SERVICE BULLETIN

N° 189-295

ATA 34 – GLIDE SLOPE ANTENNA INSPECTION

Figure 1

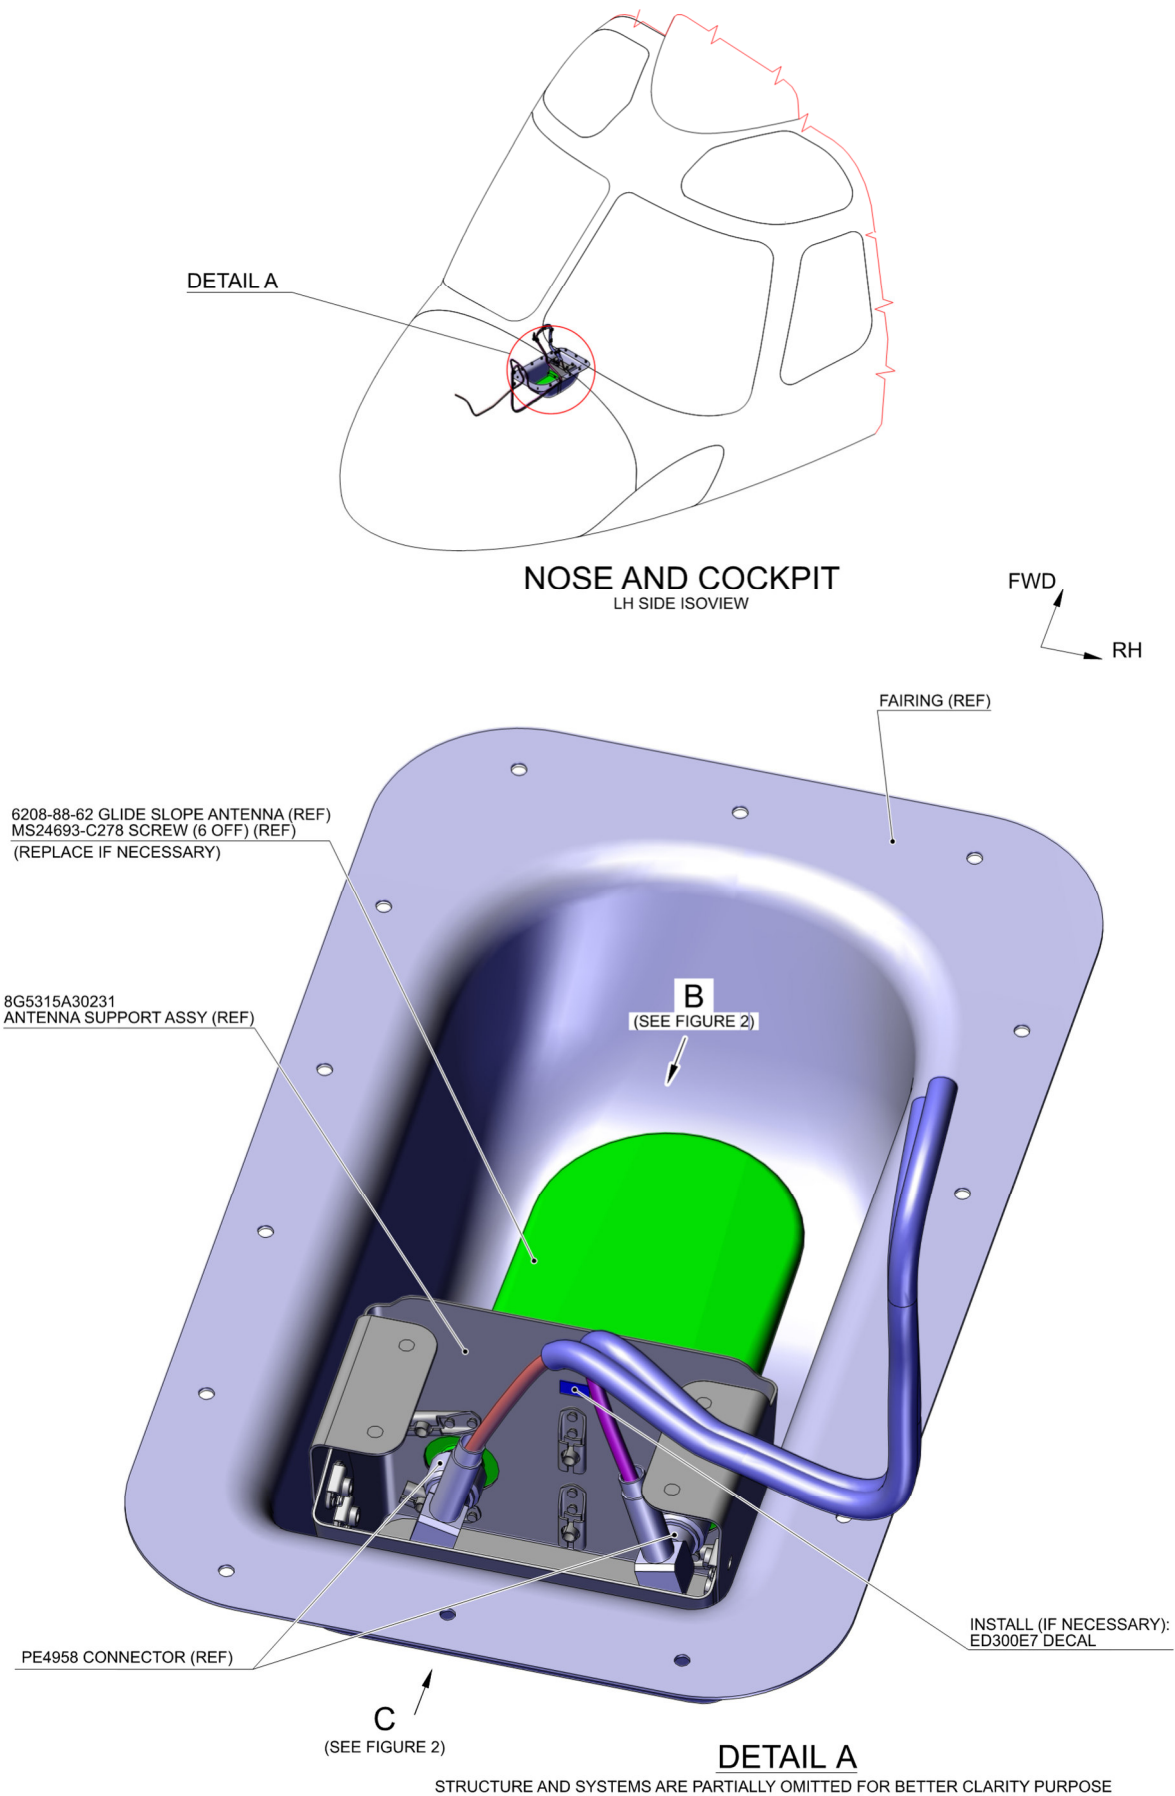
2. In accordance with AMP DM 89-A-06-41-00-00A-010A-A and with reference to Figure 1, gain access to the Glide Slope Antenna P/N 6208-88-62.
3. In accordance with AMP DM 89-A-34-32-01-00A-520A-A and with reference to Figure 1 Detail A, remove the Glide Slope Antenna P/N 6208-88-62. Keep the hardware for later reuse.

4. With reference to Figures 1 thru 3, perform a visual inspection looking for any evidence of sealant on the following components:
 - n°2 coaxial connectors P/N PE4958

- 7. In accordance with AMP DM 89-A-34-32-01-00A-720A-A and with reference to Figure 1 Detail A, install the Glide Slope Antenna P/N 6208-88-62 by means of existing hardware.

10. With reference to Figures 1 and 2, replace the Glide Slope Antenna P/N 6208-88-62 and n°2 coaxial connectors P/N PE4958 as follows:
 - 10.1 In accordance with AMP DM 89-A-34-32-01-00A-720A-A and with reference to Figure 1 Detail A, install the new Glide Slope Antenna P/N 6208-88-62 by means of n°6 screws P/N MS24693-C278.

- 10.2 In accordance with AMP DM 89-A-11-00-01-00A-720A-A and with reference to Figure 1 Detail A, install the decal P/N ED300E7.
 - 10.3 With reference to Figure 1 replace the n°2 coaxial connectors P/N PE4958.

Figure 2

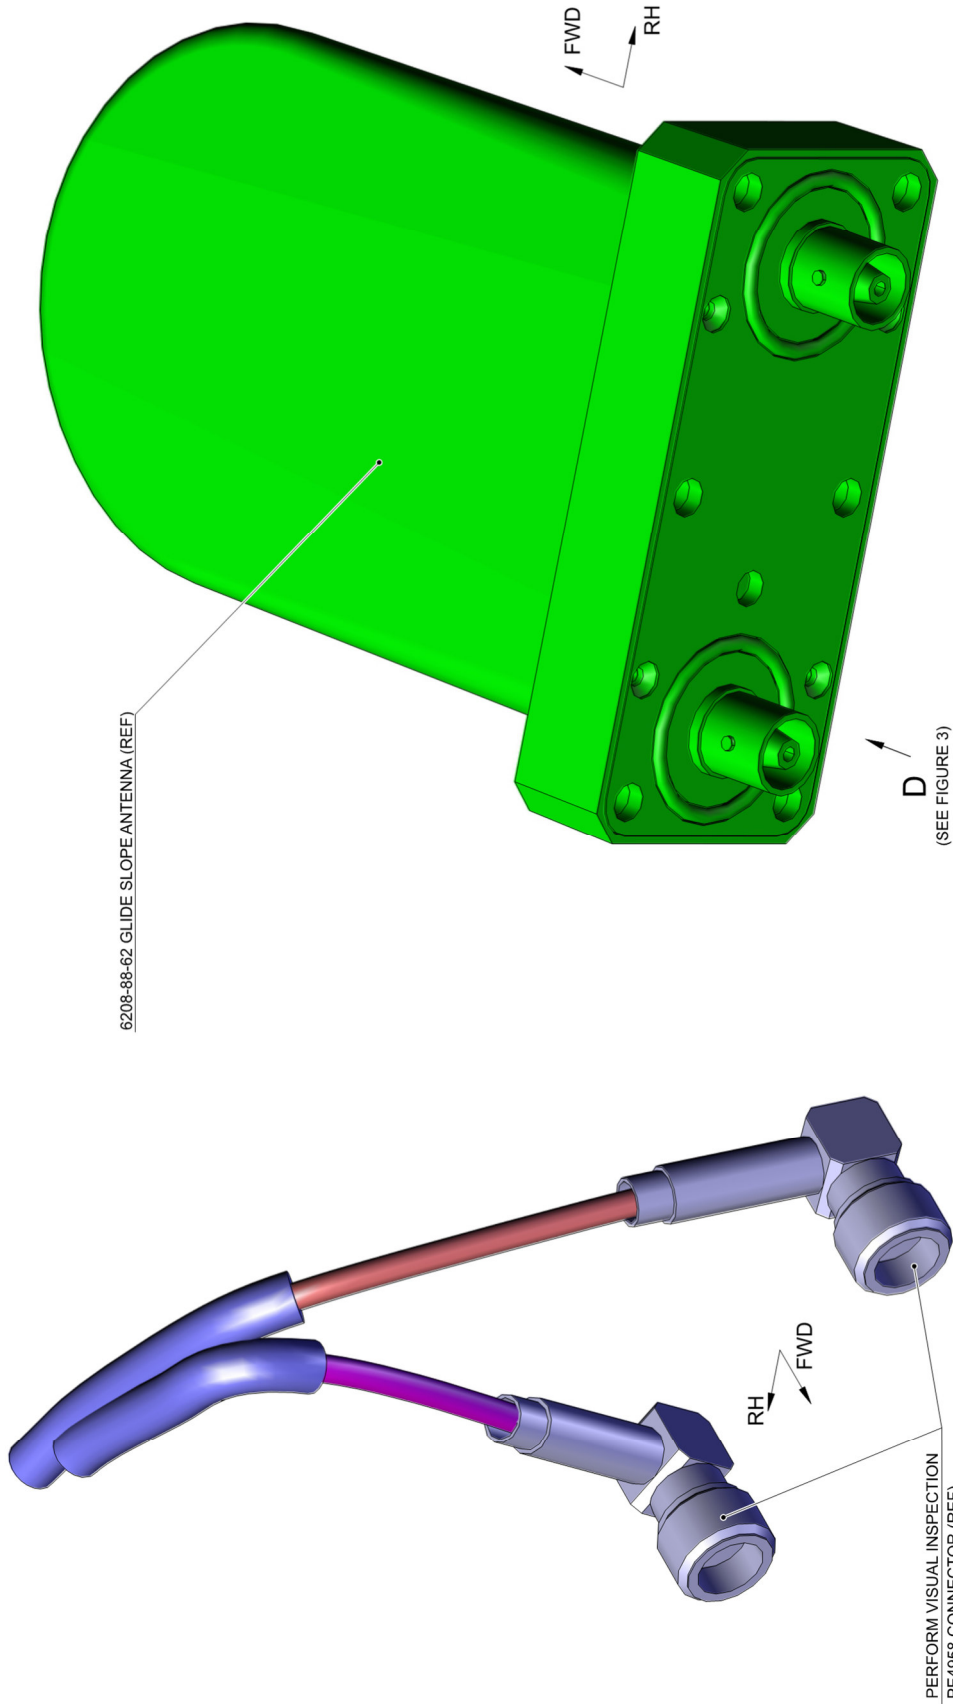
- Antenna Support Assy P/N 8G5315A30231.
5. With reference to Figures 1 thru 3, perform a visual inspection looking for any evidence of sealant around the connectors of the Glide Slope Antenna P/N 6208-88-62.

- 6.3 With reference to Figures 1 thru 3, carefully remove the sealant on all affected components by means of a plastic scraper and a lint-free cloth (C011) moistened with isopropyl alcohol (C039).
- 6.4 After the sealant removal, check that the connector plating is not damaged and that no residue remains inside the RF connectors.

Figure 3

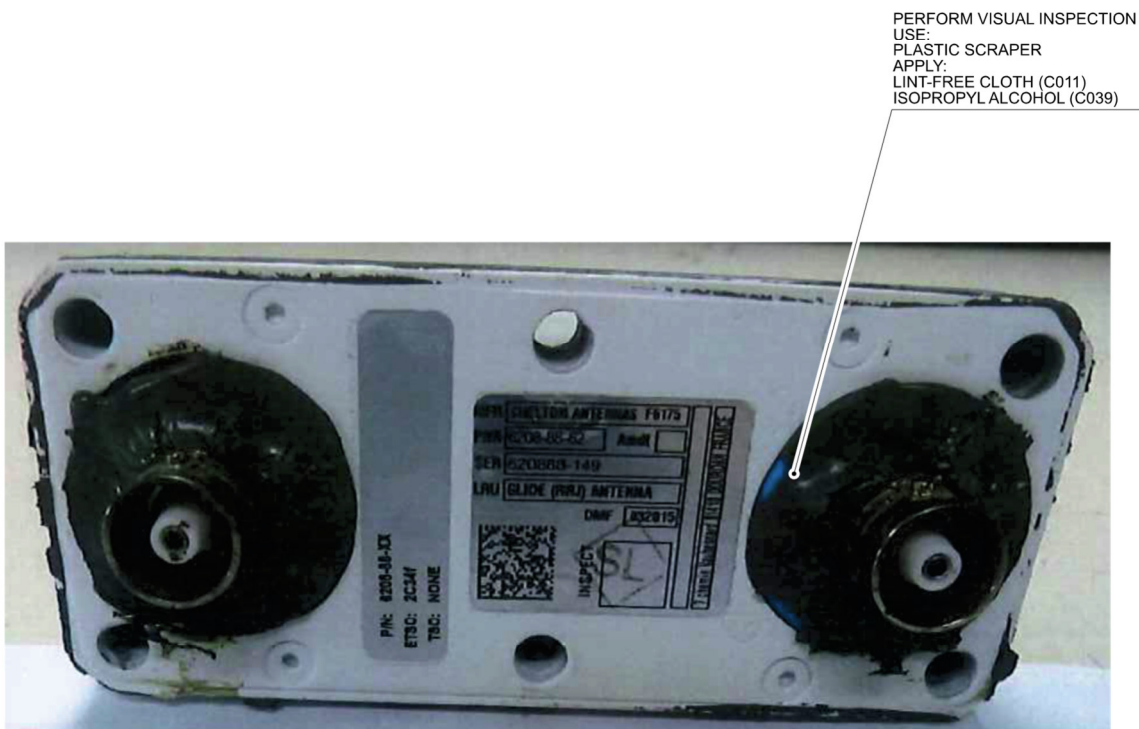
VIEW D
CORRECT ASSEMBLY PRACTICE

GLIDE SLOPE ANTENNA P/N 6208-88-62. ANTENNA CORRECTLY MOUNTED, PRESENCE OF SEALANT IS NOT FOUND.
(REFER TO FIGURE 2)

VIEW D
INCORRECT ASSEMBLY PRACTICE

GLIDE SLOPE ANTENNA P/N 6208-88-62. ANTENNA CORRECTLY MOUNTED, PRESENCE OF SEALANT IS NOT FOUND.
(REFER TO FIGURE 2)
